## 2146 SOUTH IRVINE - SOUTH FACADE ELEVATION OPTION

## **PROPOSED METAL PANEL COLOR LAYOUT:**

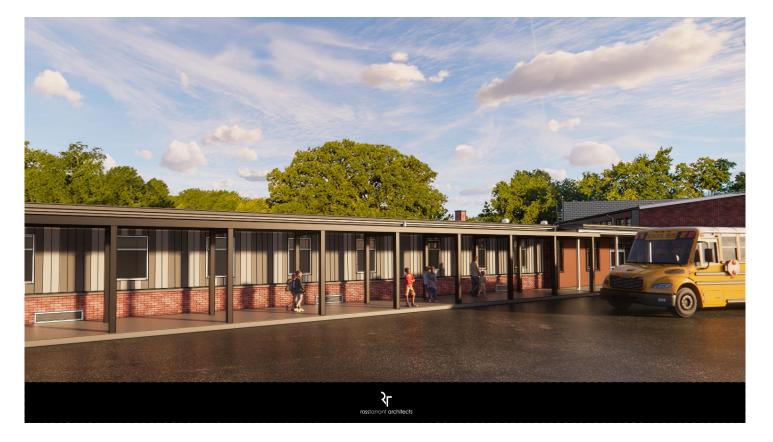
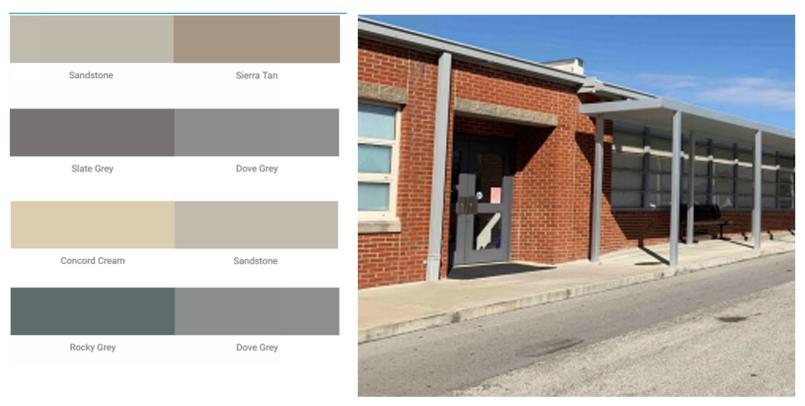
CRTA IS REQUESTING CONFIRMATION ON COLOR PATTERN INTENT.
